# UNITED STATES PATENT AND TRADEMARK OFFICE

APPLICATION NO.	FILING DATE	FIRST NAMED INVENTOR	ATTORNEY DOCKET NO.	CONFIRMATION NO.
10/781,180	02/18/2004	Yasutoshi Tasaka	2083.69735	1822
7590 10/15/2007 Patrick G. Burns, Esq. GREER, BURNS & CRAIN, LTD. Suite 2500 300 South Wacker Drive Chicago, IL 60606			EXAMINER NGUYEN, HOAN C	
			ART UNIT 2871	PAPER NUMBER
			MAIL DATE 10/15/2007	DELIVERY MODE PAPER

<b>Office Action Summary</b>	Application No.	Applicant(s)	
	10/781,180	TASAKA ET AL.	
	Examiner	Art Unit	
	HOAN C. NGUYEN	2871

### **DETAILED ACTION**

FIG. 4A

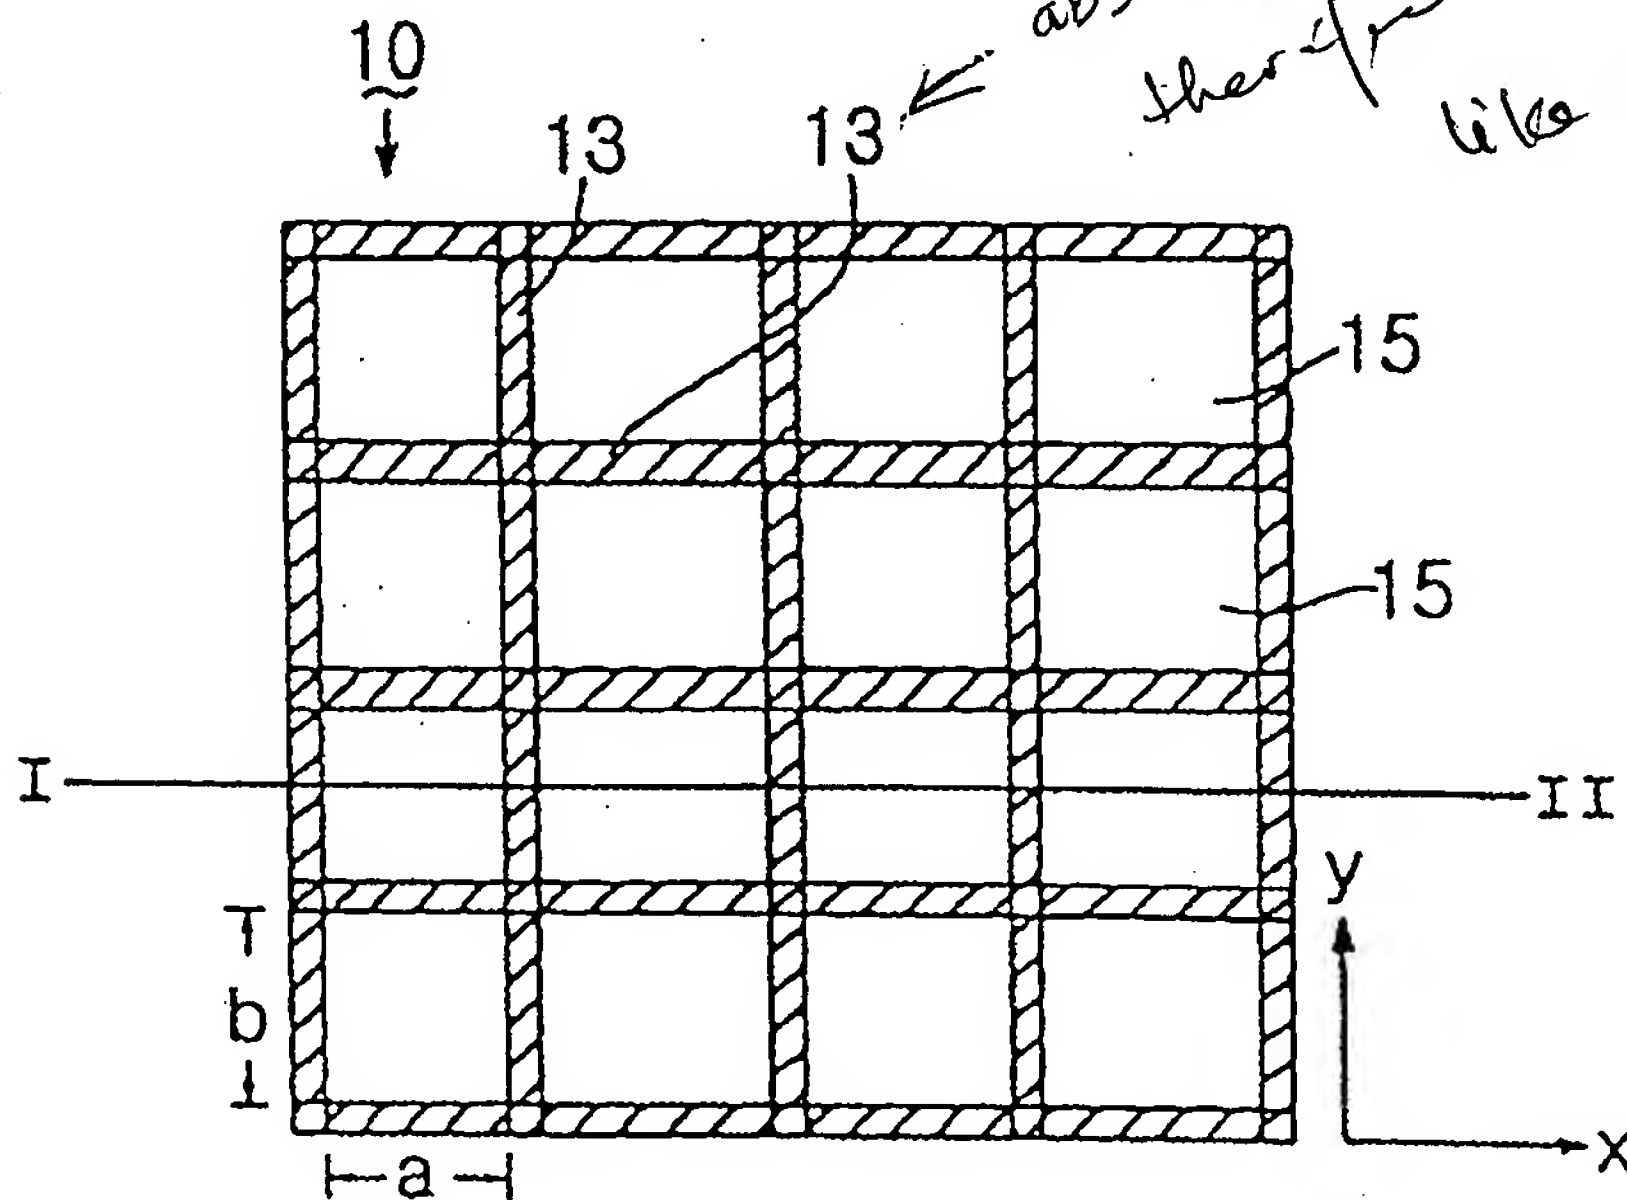
Examiner considers the combination of the polarizer 10 disposed on the passive mask 80 as mask, which cited in claims 26-27 and 29.

First, the polarizer 10 comprises

- one or more quartz substrate parts 15 formed as a rectangle, and
- polarizer holders 13 formed as a lattice structure supporting quartz substrate part

wherein **the polarizer holders 13 are made of optically absorptive material** (col. 4 lines 4-5) thus the polarizer holders 13 act as the light shielding in the mask configuration. Therefore, the polarizer 10 itself can perform as the mask, which has structure of square-lattice structure.

Second, the combination of the polarizer 10 disposed on the passive mask 80 will consider as a mask, which comprising a plurality of cavities having oblique surfaces for changing the path of light incident on the mask (see attachment).
